Planning Commission Staff Report

Meeting Date: July 26, 2021

Description: **Downtown Chesterfield Category C, Lot B (AC Hotel) Sign Package:** A request for a Sign Package to establish sign criteria for a 3.5 acre tract of land located northeast of the intersection of Wild Horse Creek Road and Old Chesterfield Road.

Figure 2: Building Sign Location

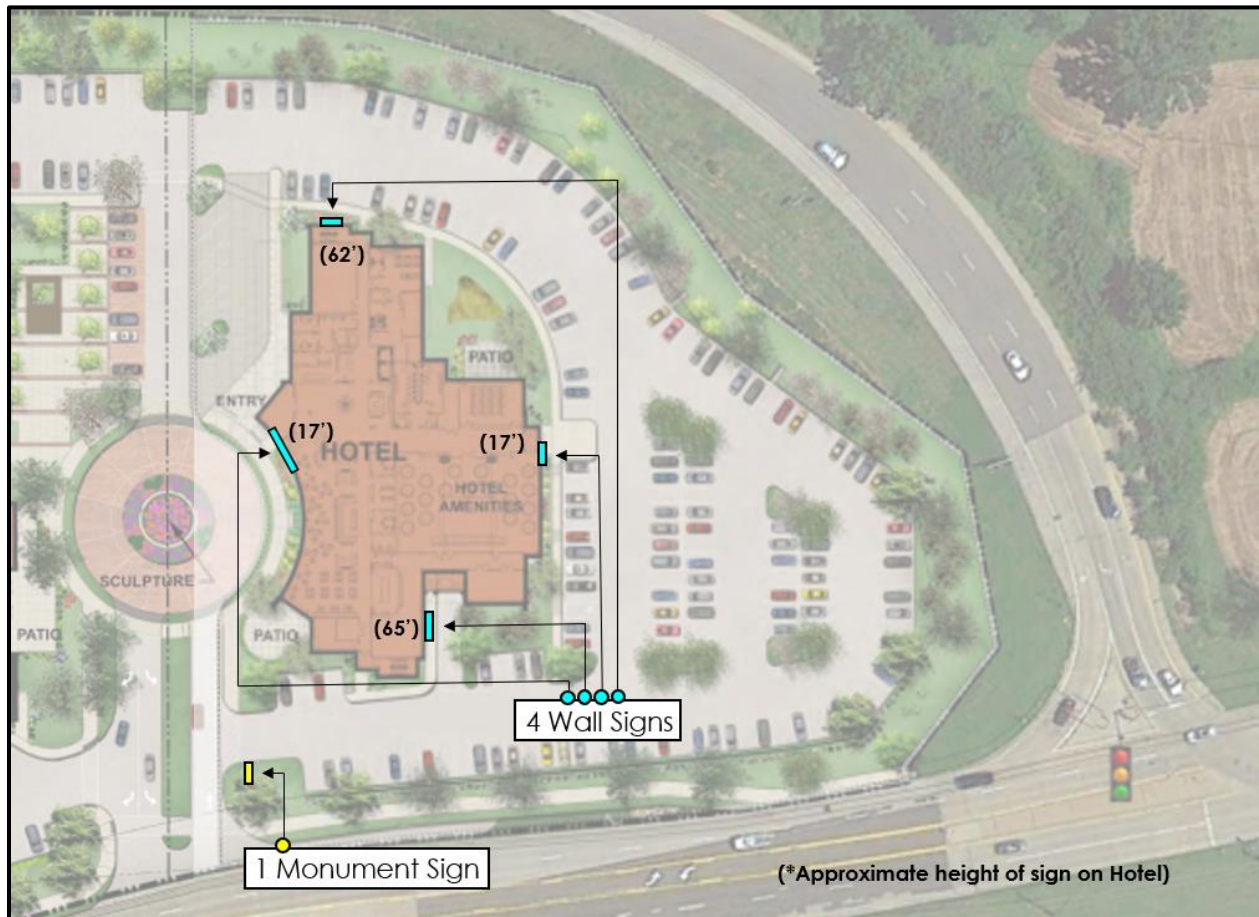
The applicant is requesting 4 wall signs. The applicant is requesting 2 on the east elevation, 1 on the north elevation, 1 on the west elevation. The image below (Figure 2) depicts the location of the wall sign on their respective elevations accompanied by the approximate height at which they will be applied to the building. The exact placement of the sign location and the exterior material they would be applied to may be seen on the color elevations included in the sign package packet.

If the sign package is approved it would permit 2 signs on the east elevation where the City’s UDC only allows staff to approve 1. Although there would be 2 signs, the total outline area of both signs would be under the maximum (300 SF). Below is a table outline what the UDC permits without a sign package in comparison to what the applicant is requesting through the sign package mechanism.

Two of the wall signs are defined as rooftop signs in accordance to the Unified Development Codes’ signage terms. These signs are affixed to the top of a canopy and located above the canopy vs affixed to the side of the canopy similar to a traditional wall sign. Rooftop signs are considered a prohibited sign and only allowed through the sign package process. The UDC definition of a rooftop sign is: “A sign erected on, over or above the roofline of a building”. The proposed signs are situated on the canopy over the first floor of the five story building. Below is an example image of the placement of the sign affixed to the top of the canopy.
